AGENDA  
City of Milton  
Virtual Plan Commission Meeting  
October 6, 2020  
4:00 pm

**To:** Mayor Welch, Milton Plan Commission  
**From:** Howard Robinson, Director of Public Works  
**Date:** October 6, 2020  
**Subject:** Public Hearing, Discussion and Possible Action Regarding a Site Plan Review and a Conditional Use Permit for 401k Properties Located at 645 College Street.

**To:** Mayor Welch, Milton Plan Commission  
**From:** Howard Robinson, Director of Public Works  
**Date:** October 6, 2020  
**Subject:** Discussion and Possible Action Regarding a Site Plan Review for a Dairy Queen at 1167 Gateway Drive.

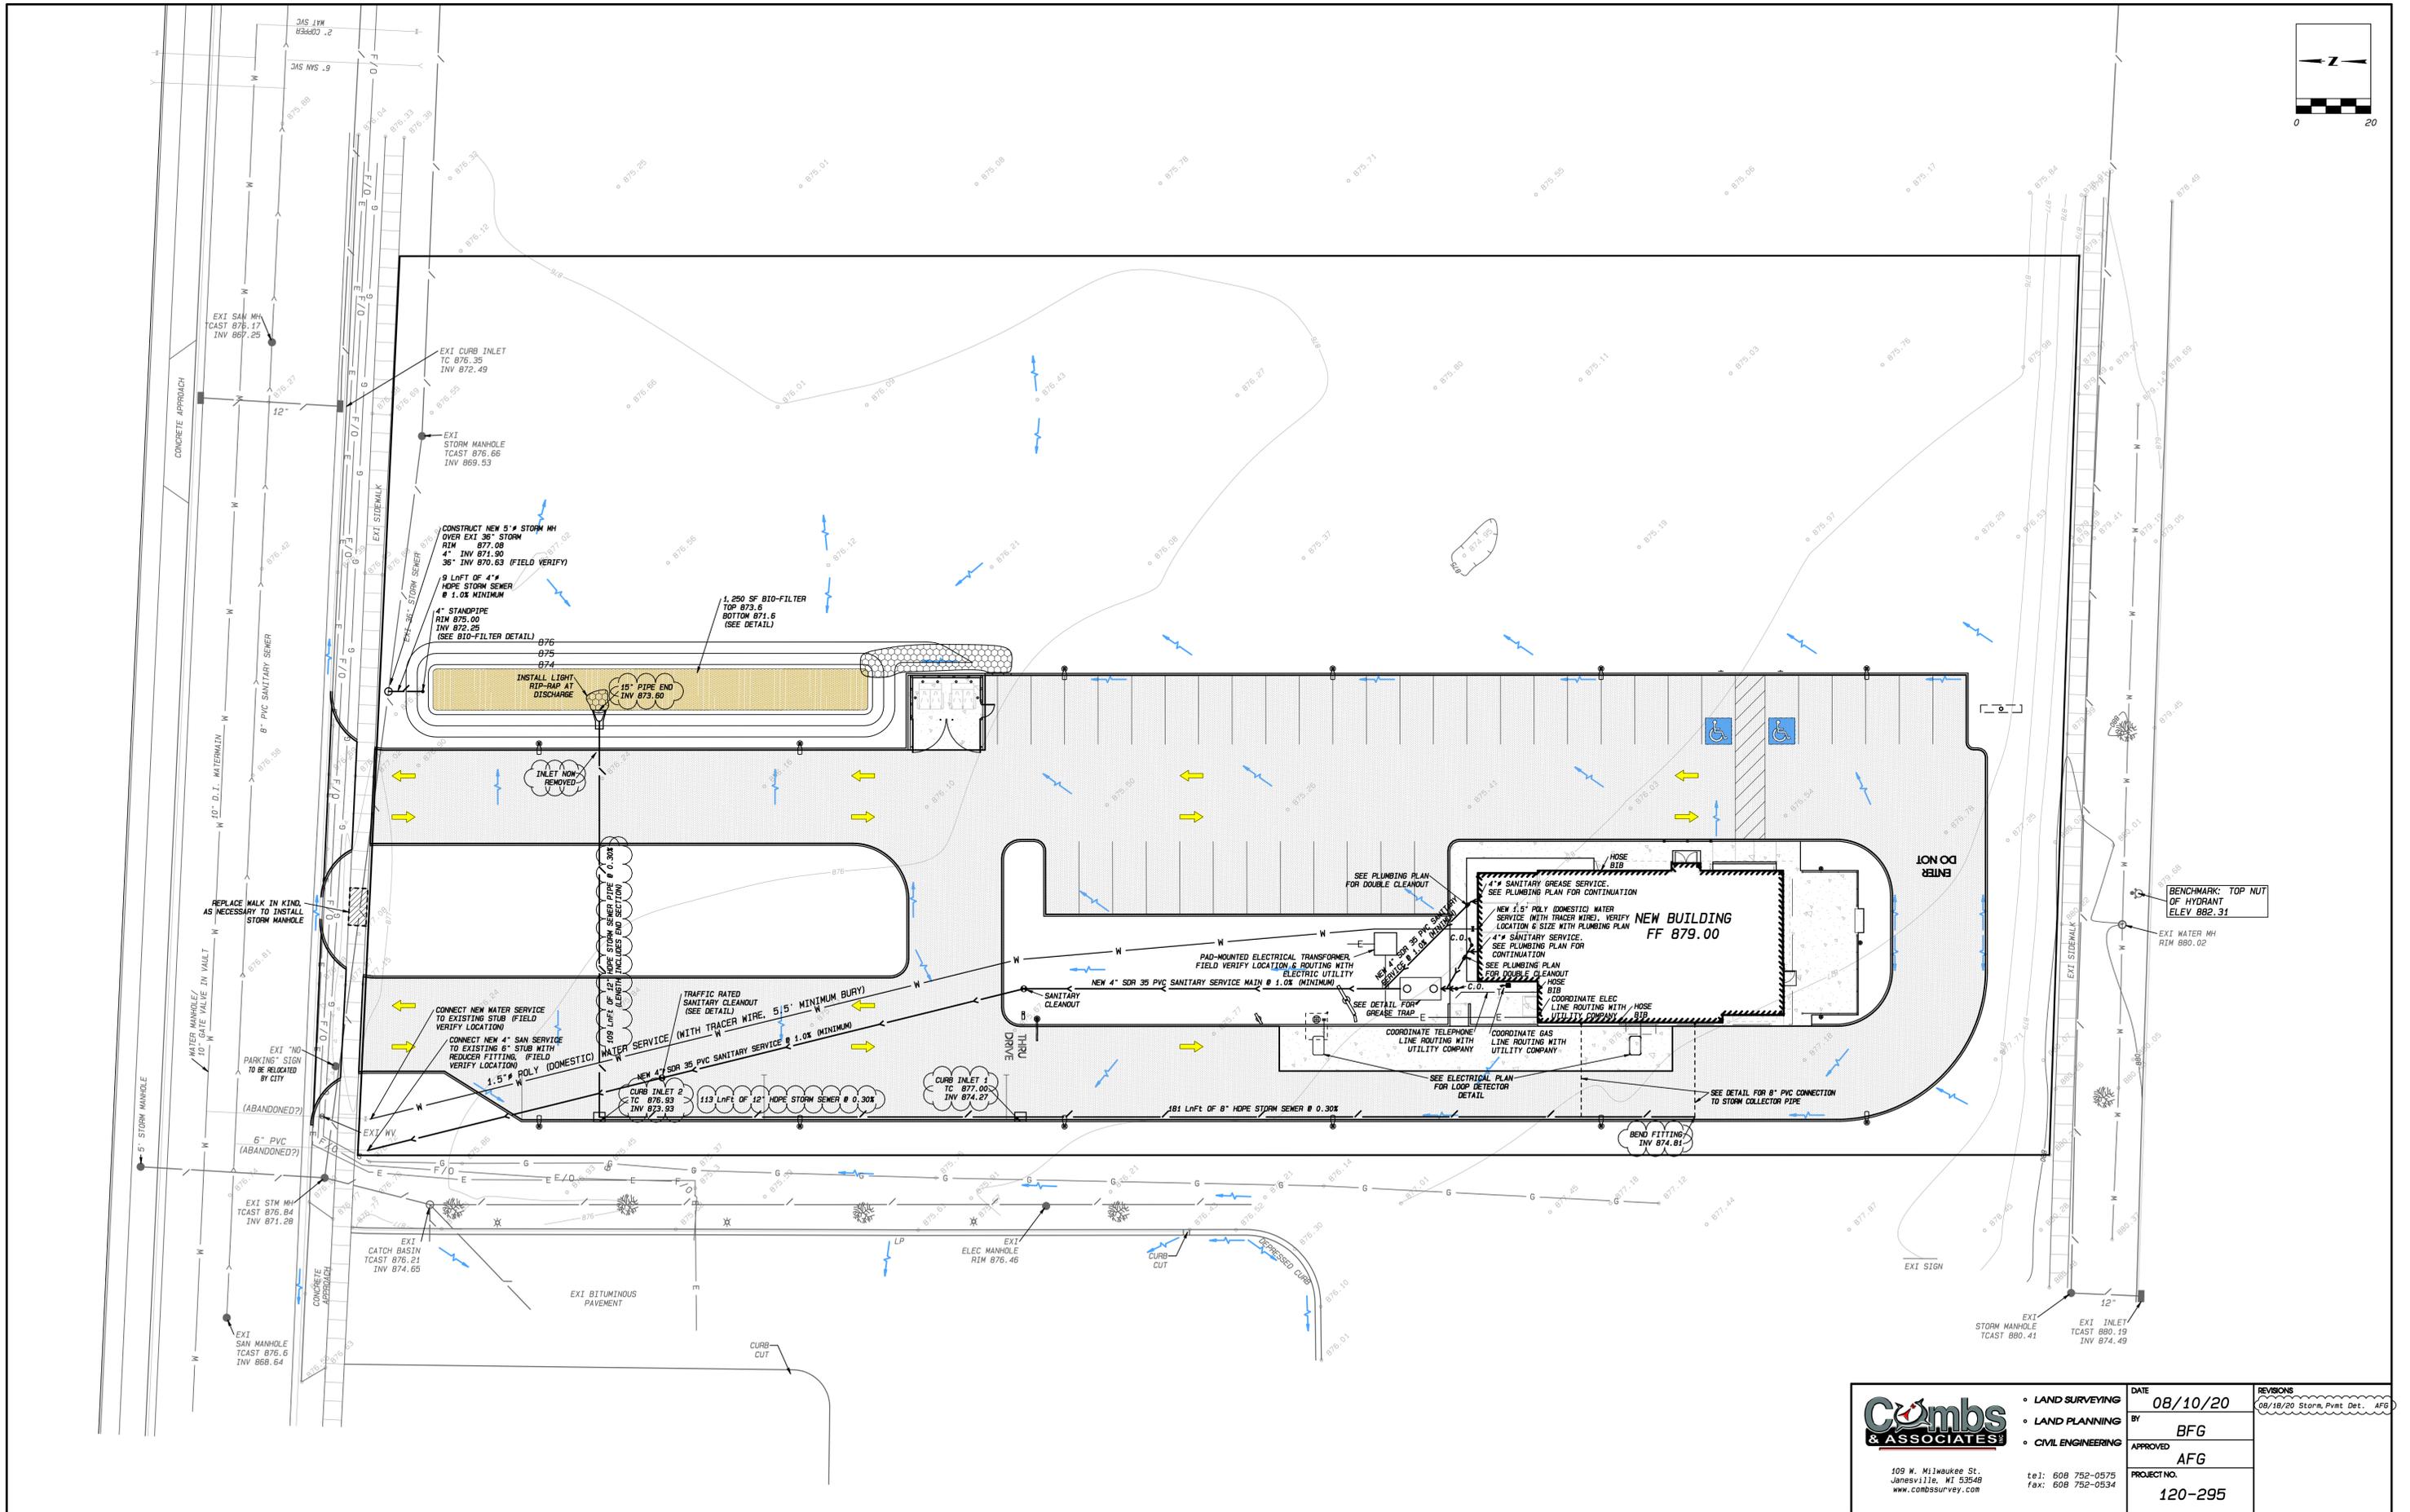
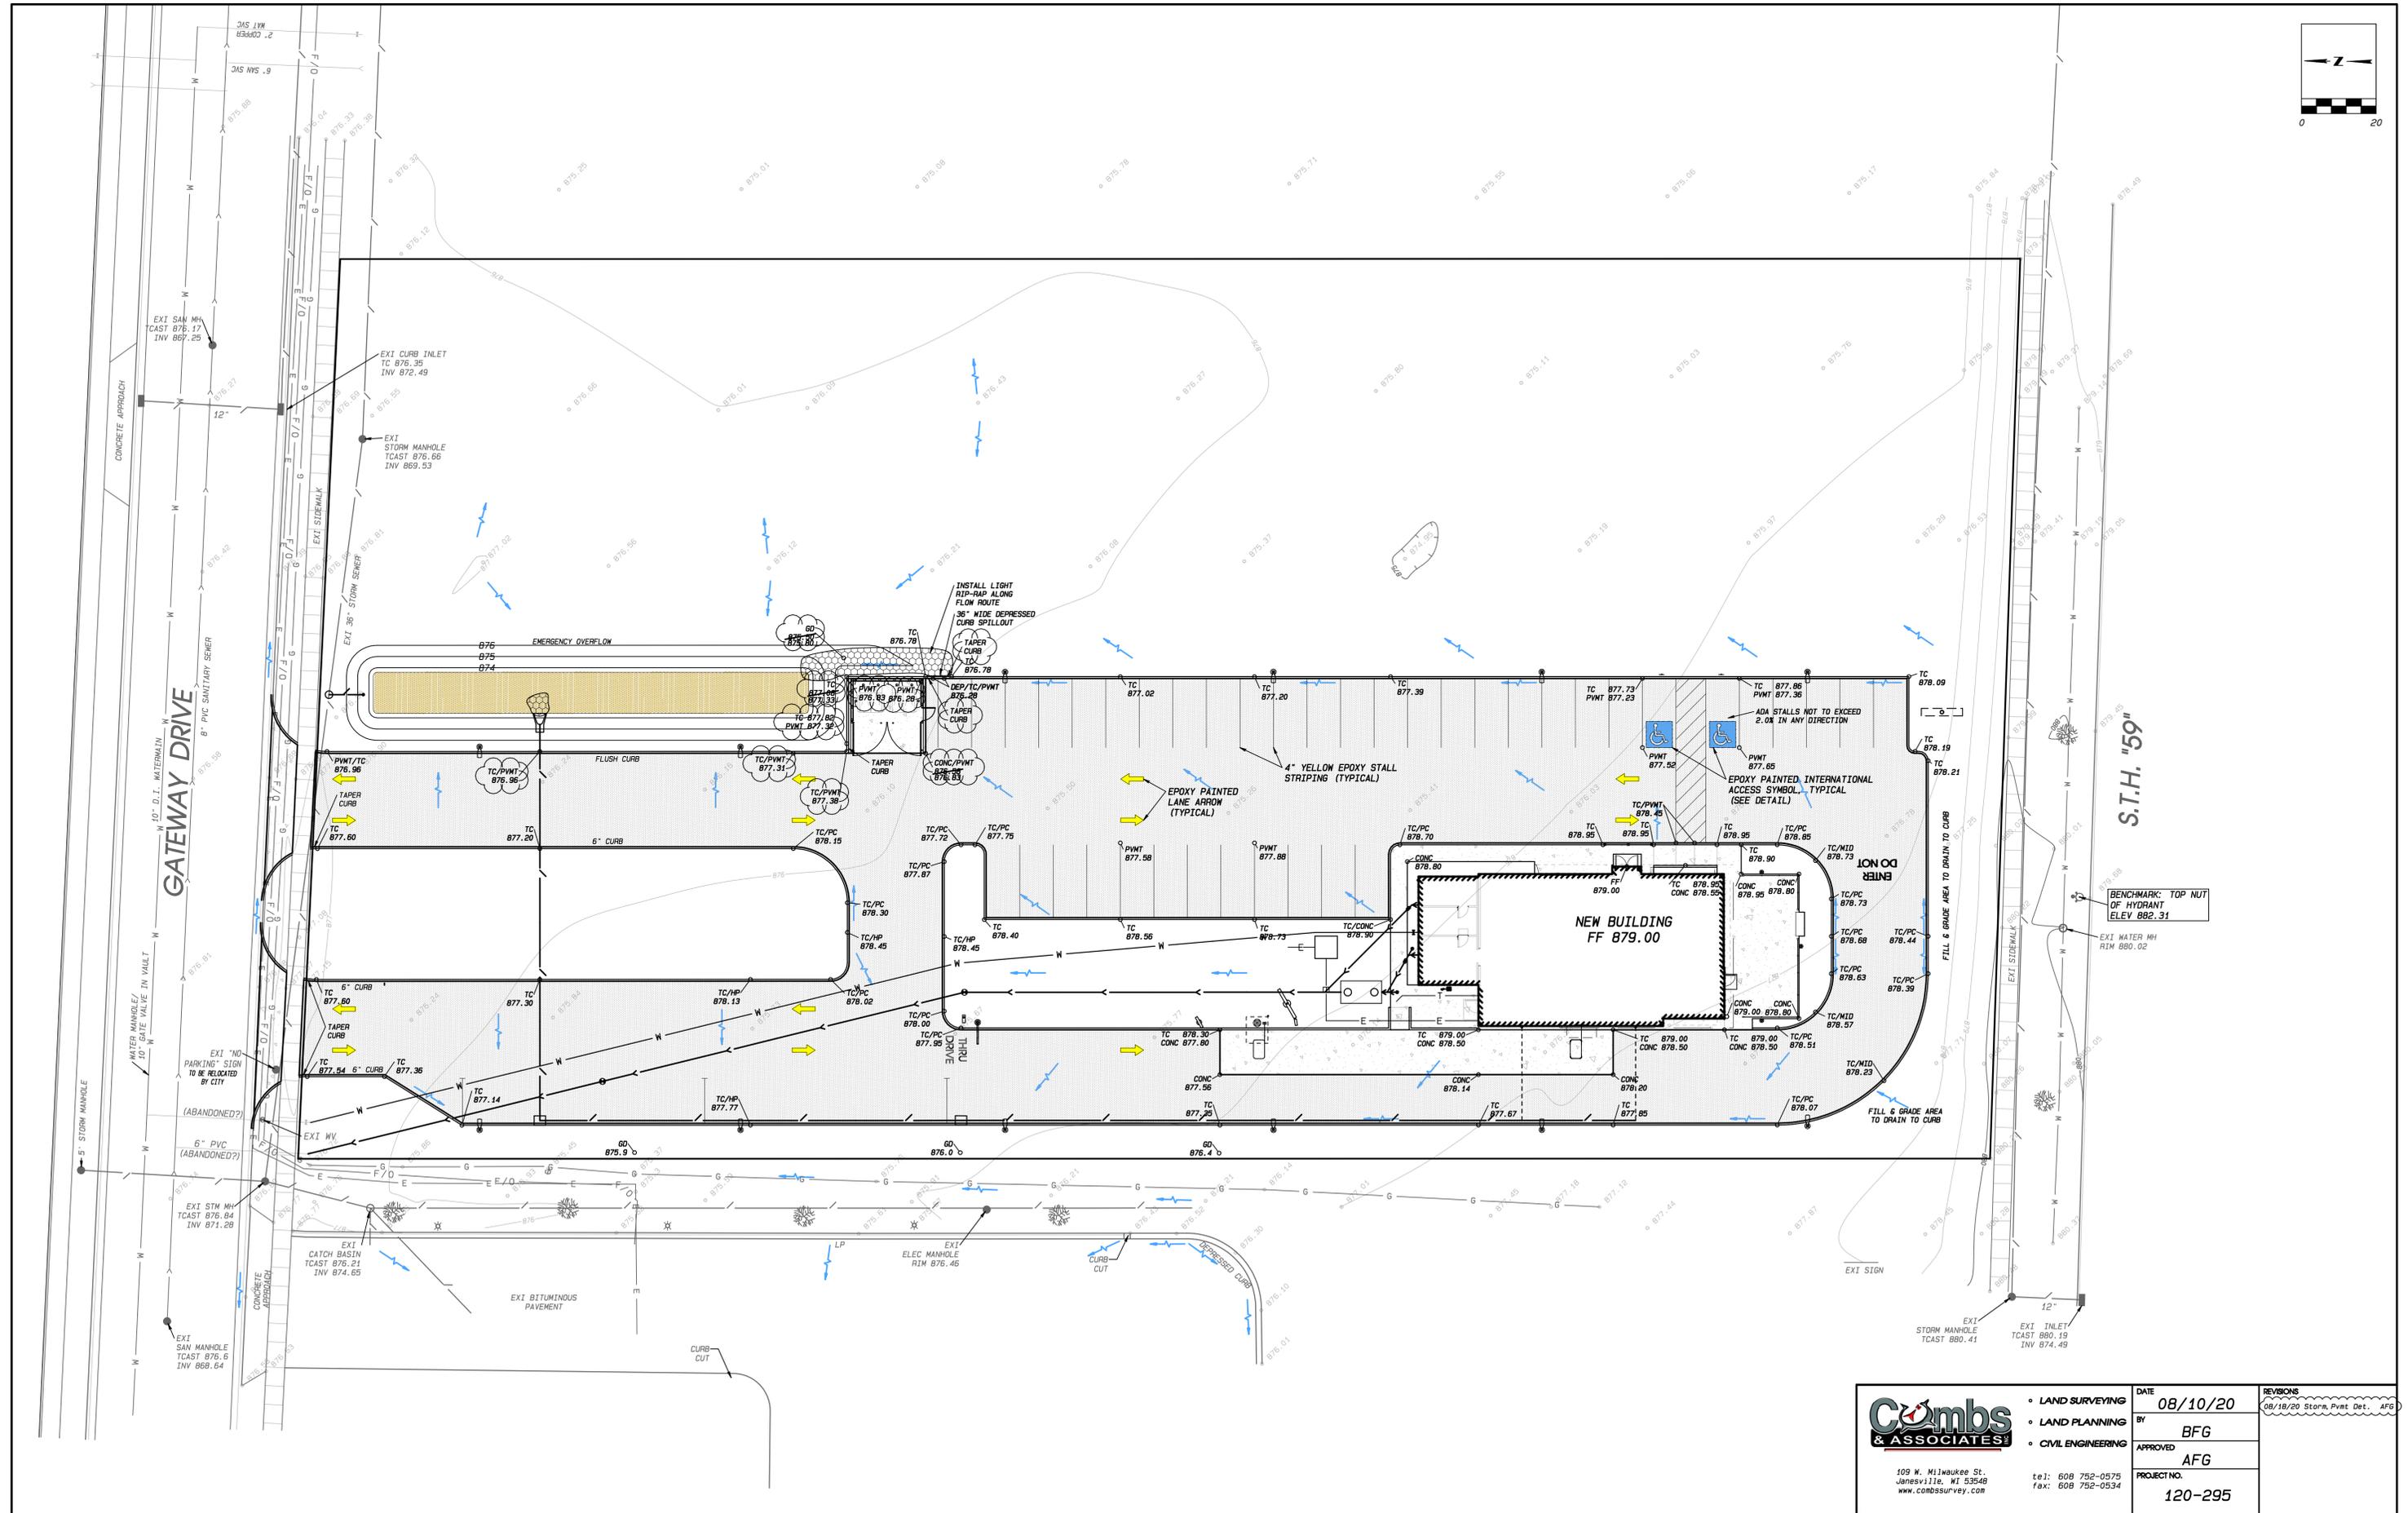
A Dairy Queen is planned to be constructed at 1167 Gateway Drive. This is the lot east of Kwik Trip. The lot is zoned B-2. A site plan has been submitted. The site plan will meet ordinance requirements with the contingency of completing the following items for the site plan:

- Storm Water Plan - Required to indicate revision dates and language describing the drainage pipes, mains, inlets, cleanouts, etc.
- The biofilter (onsite stormwater area) can only be mowed to a height of no less than 6". City Engineer Mark Langer will verify these corrections when submitted.
- Roof top HVAC units will require screening..

City staff recommends approval of the site plan with the above contingencies for a Dairy Queen at 1167 Gateway Drive.
